Harwell Link Road - HarBUG Response to Development Proposals

Effect of Proposed Developments on Existing Main Cycle-Commuter Routes

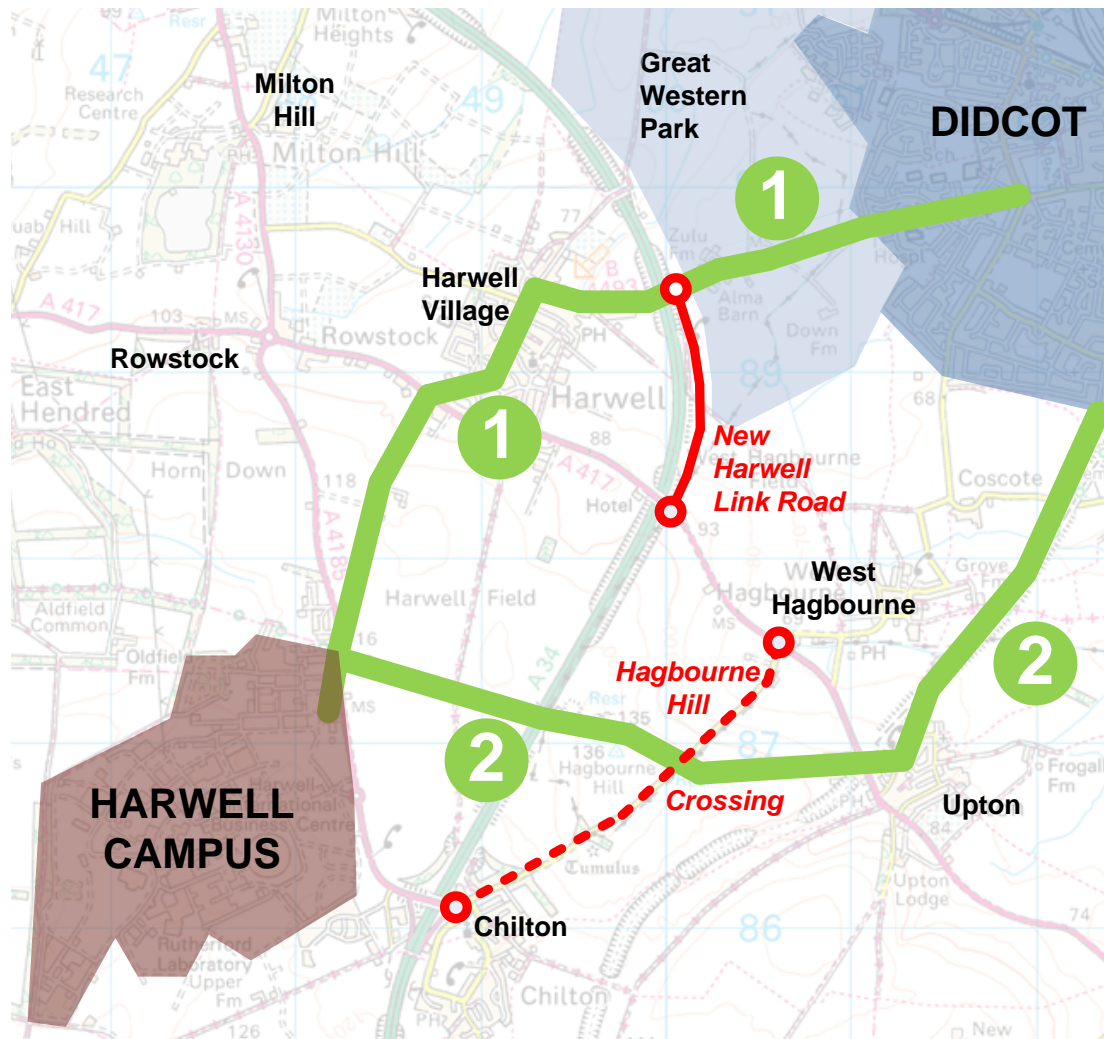
The proposed Harwell Link Road development directly affects existing, major cycle-commuter routes between Didcot and Harwell Campus. Please refer to appended map below.

- The new Link Road will help cyclists by removing through-traffic from Harwell Village. The B4493 road through Harwell village is already one of the most important cycle routes from Didcot to Harwell Campus (refer to map). Together with the already-authorized Winnaway upgrade, the improved conditions for cyclists in Harwell Village are likely to further increase cyclist numbers.
- However, these same cyclists will be affected by the major new roundabout on B4493 at the North end of new Link Road. Furthermore, it is anticipated that overall traffic volumes will increase on the existing B4493 (Wantage Road) into Didcot – at least until the Link Road is extended all the way down to the proposed Science Bridge. Cyclists on existing B4493 have already been disadvantaged by the very poorly-designed cycle infrastructure installed as part of the Great Western Park development.
